Battery Cable Verification

Bulletin Type:	SRP	Publication Date:	June 2024
Bulletin #(s):	24-013	Make(s):	Entegra
Job Code(s):	<i>If affected unit has warranty remaining, submit your claim following the normal process</i>	Model(s):	Cornerstone, Anthem, Aspire
Flat Rate(s):		Model Year(s):	2017-2024

BATTERY CABLES INSPECTION

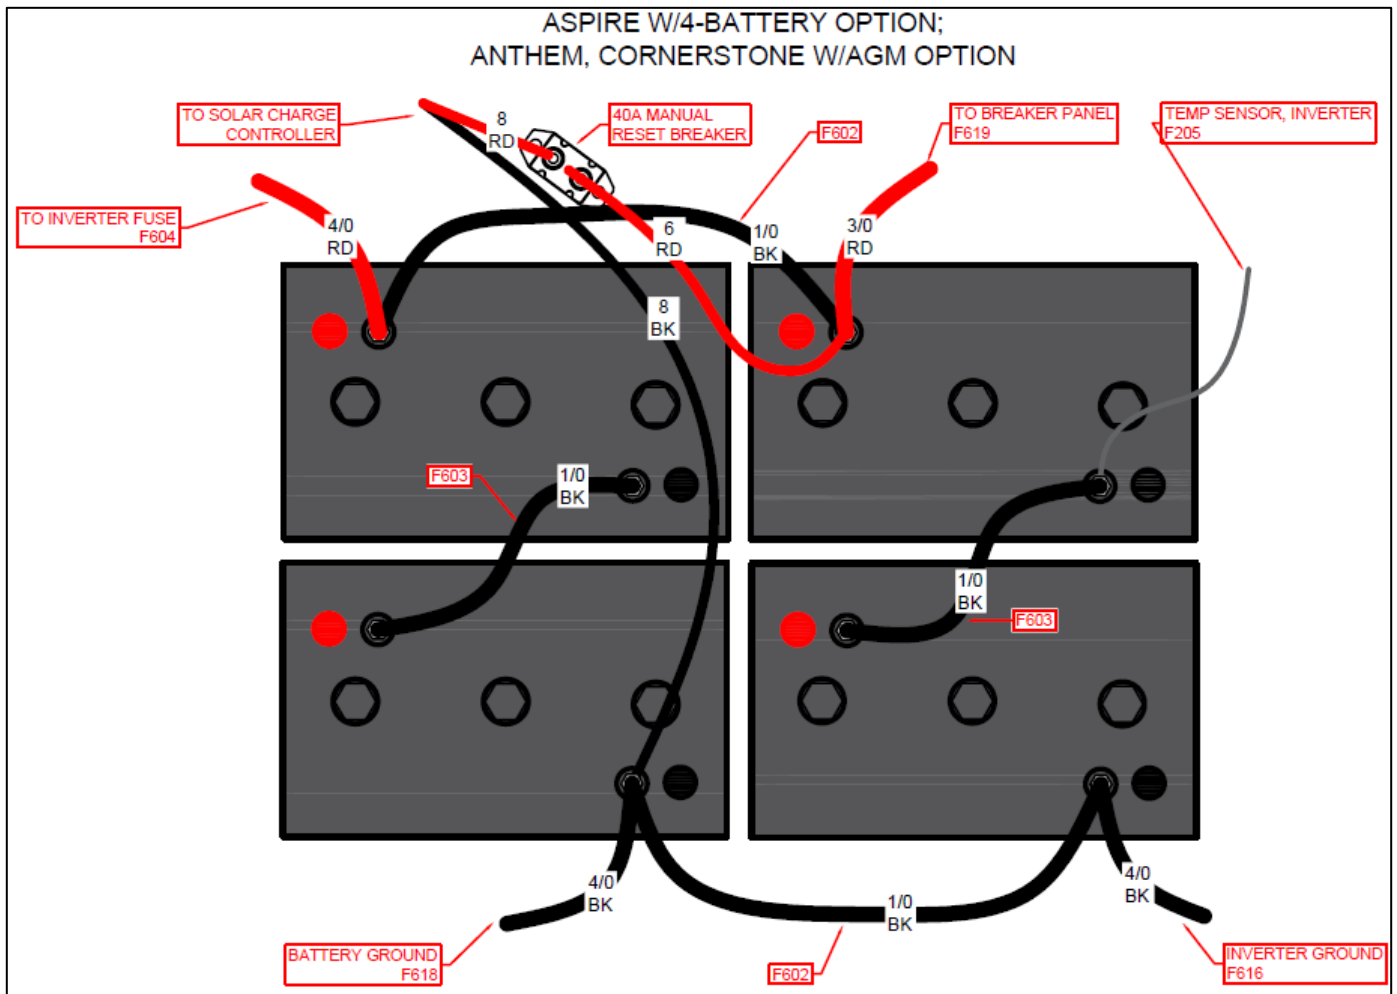
1. Verify battery cables are hooked up as shown in diagram and to proper torques specs.
 - A. 40A Manual Reset Breaker Torque = 24 IN-LBS
 - B. **Battery Torque = 150 IN-LBS**

BATTERY CABLES REPAIR INSTRUCTION

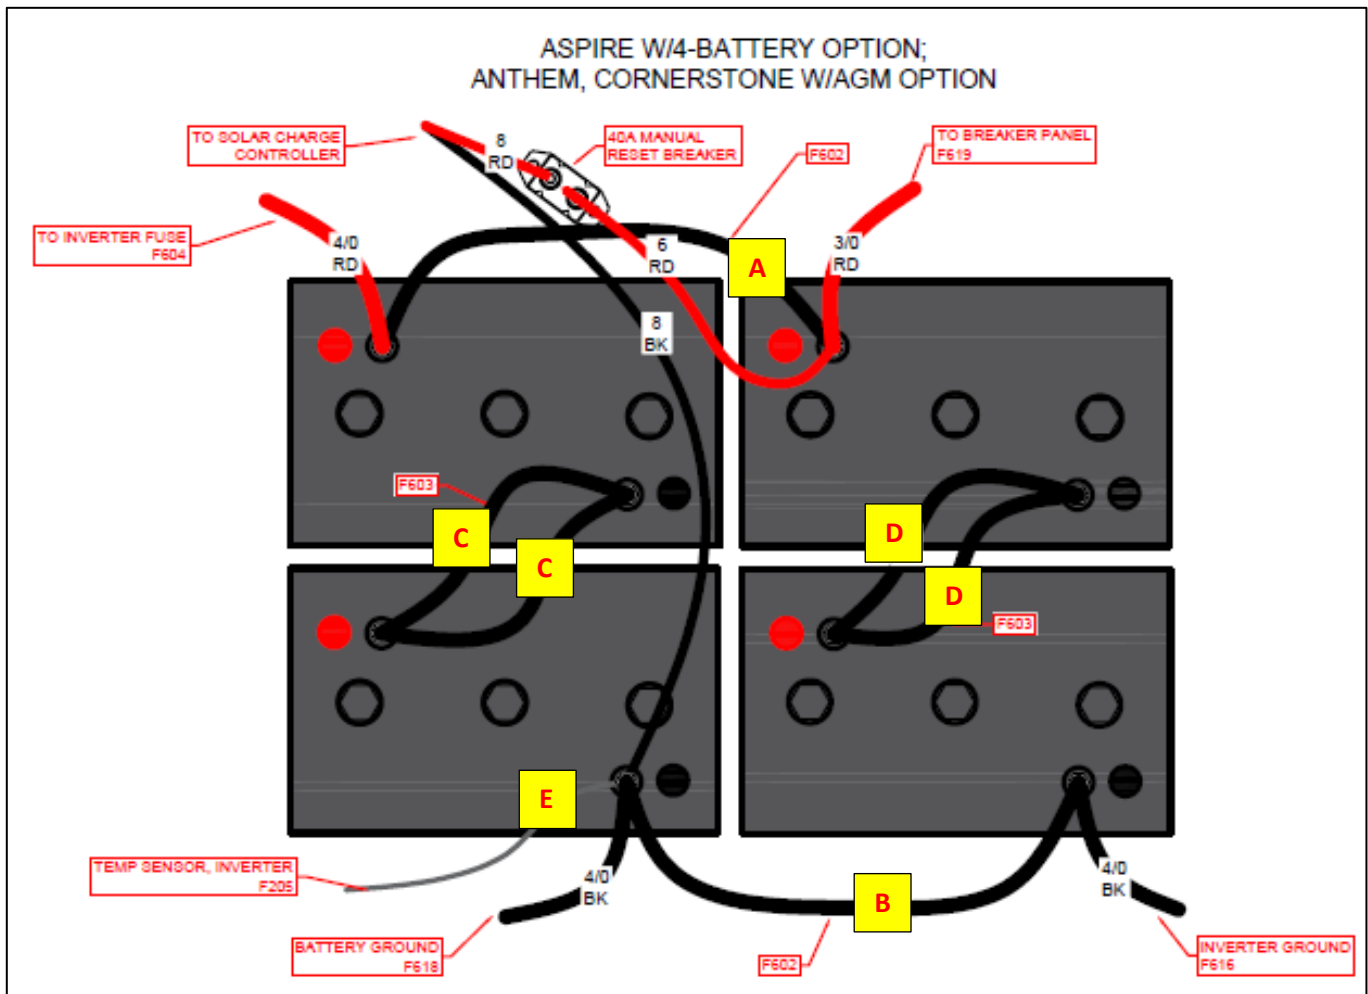
Incident:	Inverter/Charger shuts down due to high temp battery fault. Batteries were depleted below recommended voltage and upon recharge in certain conditions, the batteries would exceed normal charging temperatures.
Affected Units:	2017-2024 Aspire, Anthem, Cornerstone units built with 4 house batteries
Parts List:	2 - CABLE,BTRY 2/0 GA NEG 14" .312/.312 RNG (Jayco Part #0193120) 4 - CABLE,BTRY 2/0 GA BLK 10" .3125/.3125 RNG (Jayco Part #2057644)
Misc. Tools & Supplies:	Torque Wrench with 9/16" Socket

1. Turn off the lower disconnect switch.
2. Change the following cables:
 - a. Parallel link cable: Remove 1/0 cable and replace with 14" 2/0 cable (0193120).
 - b. Parallel link cable: Remove 1/0 cable and replace with 14" 2/0 cable (0193120).
 - c. On series connection (left bank): Remove 1/0 Cable and replace with (2) 10" 2/0 battery cable (2057644).
 - d. On series connection (right bank): Remove 1/0 Cable and replace with (2) 10" 2/0 battery cable (2057644).
 - e. Move battery temp sensor to left parallel negative post
 - f. **Torque all connections = 150 IN-LBS**

3. Turn on the lower disconnect switch.
